NOTICE OF MEETING
PLANNING AND ZONING COMMISSION
6:00 P.M. – January 12, 2023
30360 Cougar Bend, Bulverde, TX 78163

PLANNING AND ZONING COMMISSION ITEM:
PC-22-48
FINAL PLAT
Park Village Unit 7

PLANNING AND ZONING COMMISSION ITEM:
PC-22-50

SUBJECT: Replat of Lots 65-67, Shepherds Ranch Unit 4 **DATE:** December 21, 2022
Establishing Lots 65R and 66R
Replat Review
PC-22-50

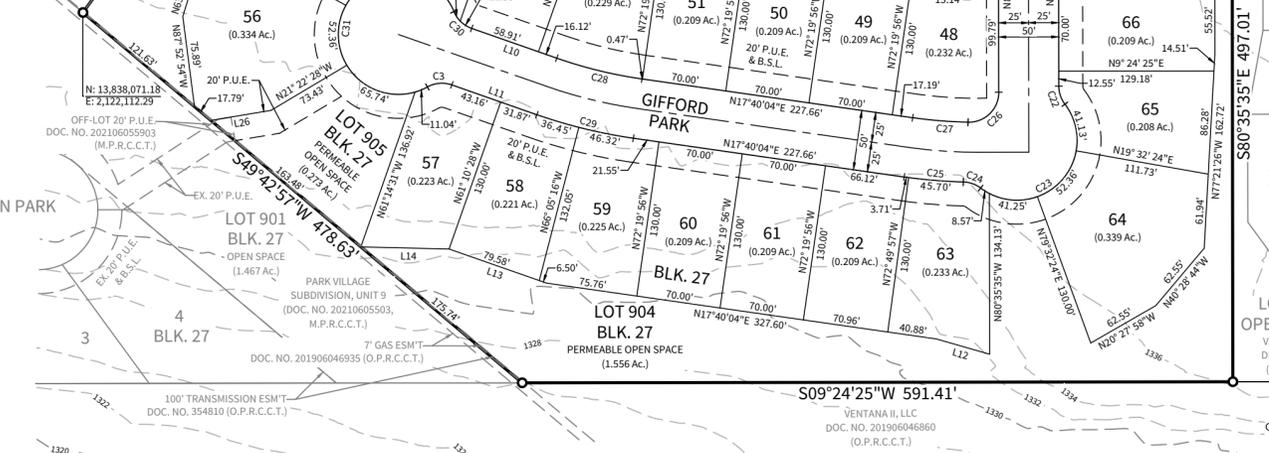
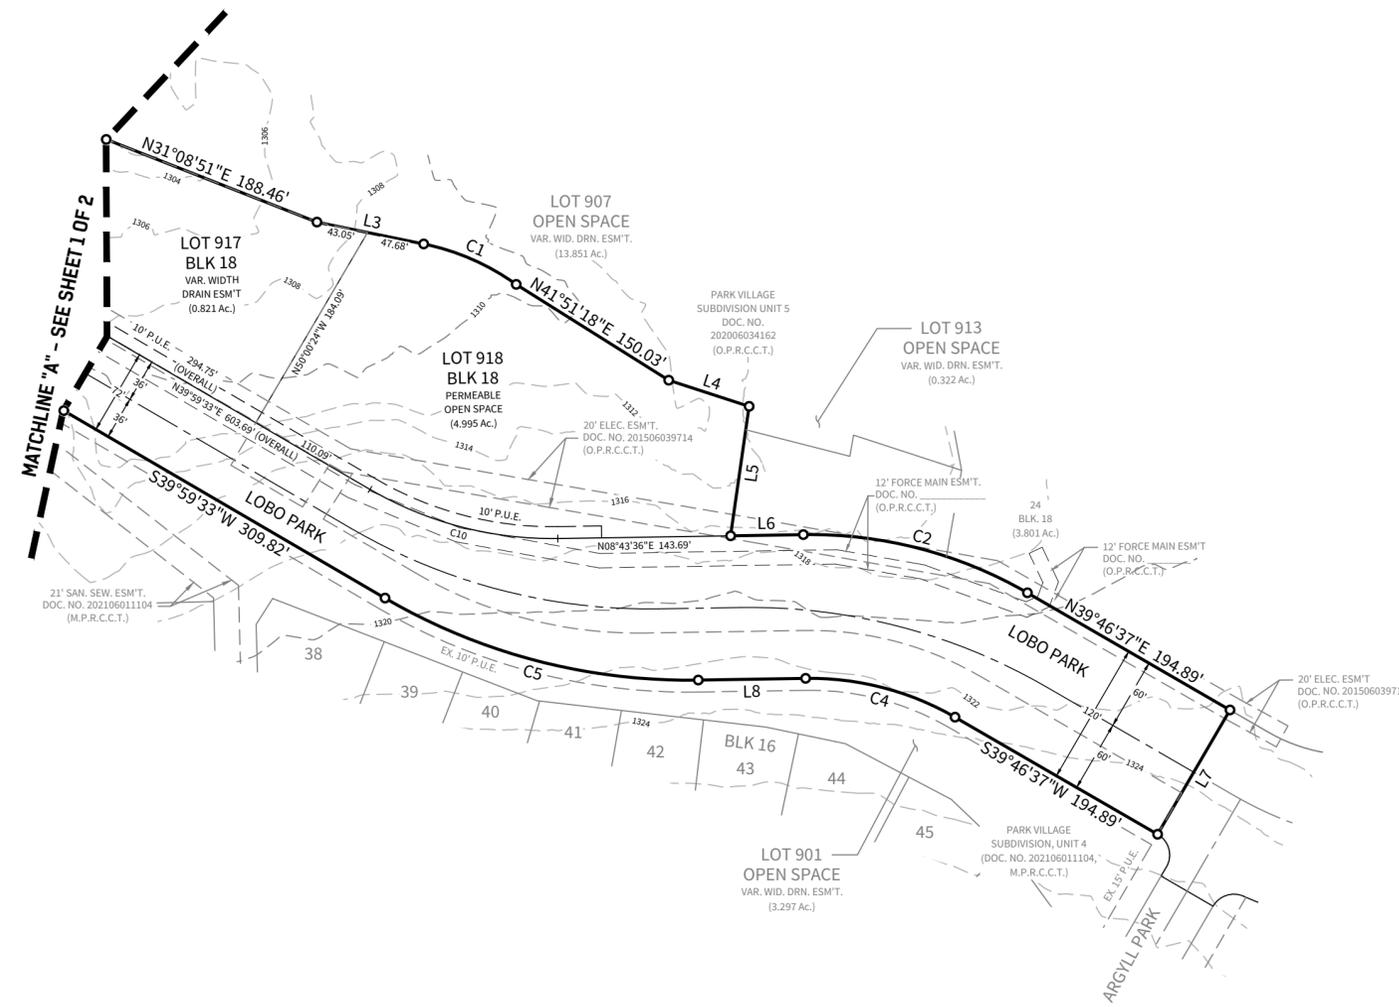
1. There are more than 3 open space lots within the plat limits. Please update General Platting Notes 8 & 9. **Comment resolved.**
2. Please update legal description to reflect the correct number of open space lots. **Comment resolved.**
3. Please update the acreage for lots 56 & 905 to account for the change in property line between the lots. **Comment resolved.**
4. Add lienholder signature block (with address) or confirmation that lean has been released. *1/4-Lienholder statement reflects Unit 8 in the description. Please revise.* **Comment resolved.**
5. Update year in P&Z block. **Comment resolved.**
6. Remove excess callout on index map: **Comment resolved.**

7. Provide a copy of the approval letter from Comal County for new street name designations.
[Comment resolved.](#)

REPLAT OF LOTS 65, 66, AND 67, SHEPHERDS RANCH SUBDIVISION UNIT 4 ESTABLISHING LOTS 65R AND 66R

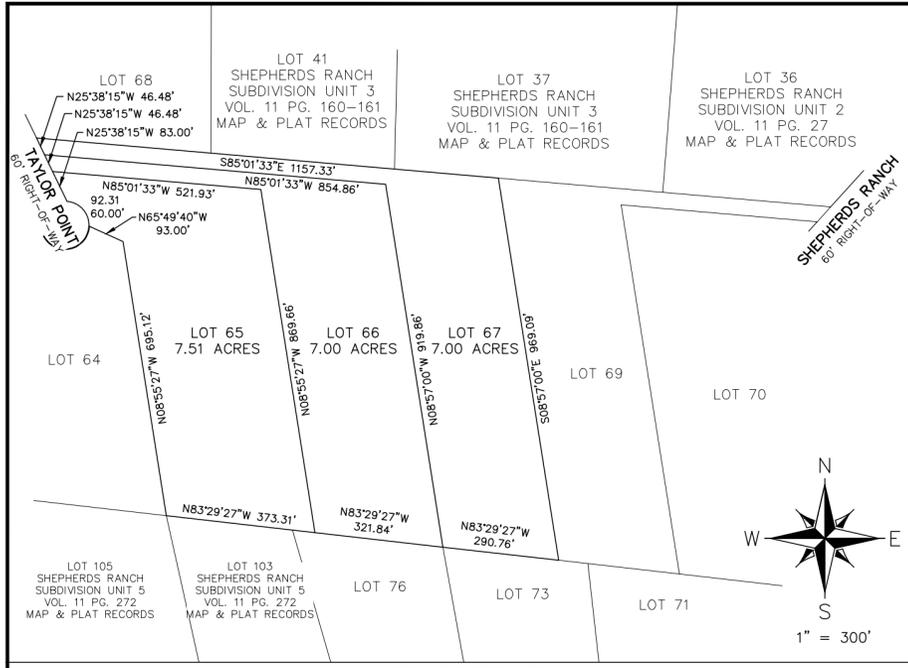
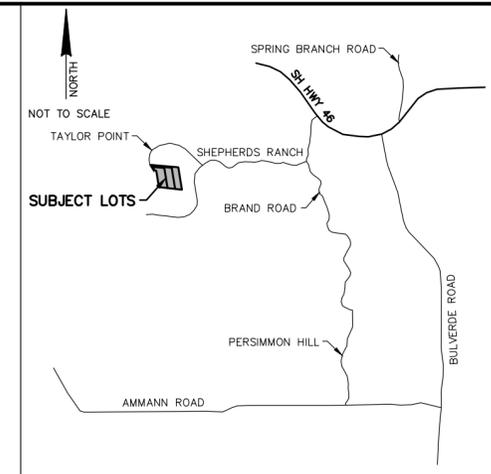
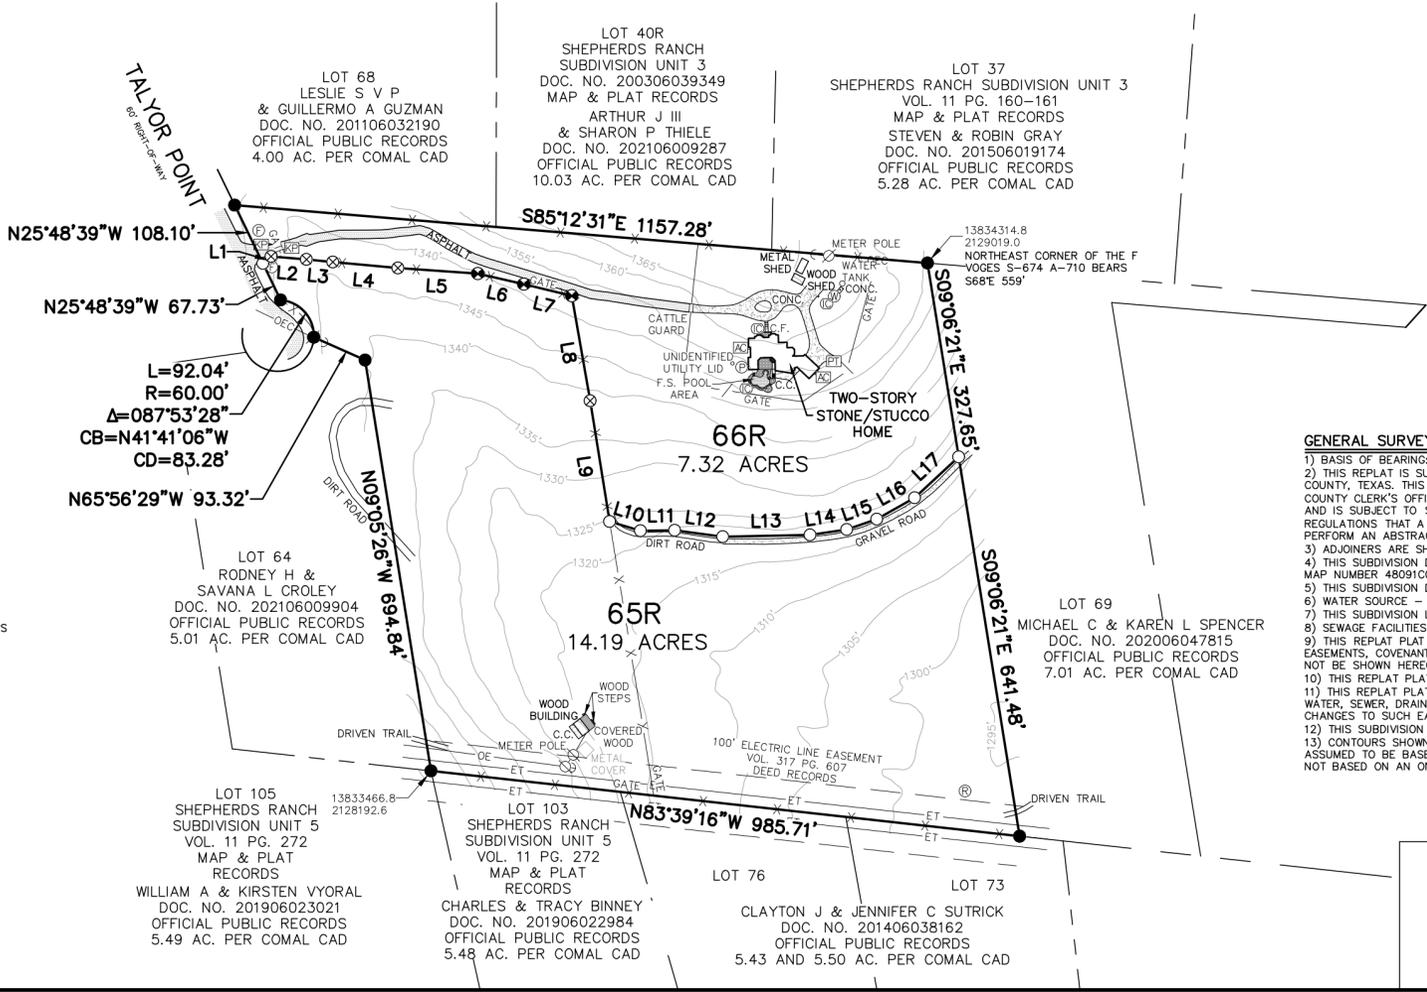
1. Please add the date of preparation to the plat.
2. Maximum scale for both area of replat and new plat layout is 1"=100'.
3. Use a heavy line in both views for the outside boundary of the area being replatted.
4. Show existing utility lines on the "area of replat" view."
5. Existing improvements (buildings, fences, utilities, etc) should not be shown on a replat.
6. New setback lines should meet the requirements of Zoning ordinance 14.03.003, and must be shown on the plat.
7. General Survey Notes #2 & #9 repeat.
8. Provide slope easements, if any exist, after preparation of Slope map, as noted in the section below.
9. Correct replat name in Planning Director & P&Z signature blocks.

1. Provide approval letters from utility companies for removal of utility lines along existing property lines.
2. Tax certificates required for each lot included in the platted area.
3. Provide property closure verification.
4. Provide a slope map, as defined by Section 4.04, and add slope easements if any exist.
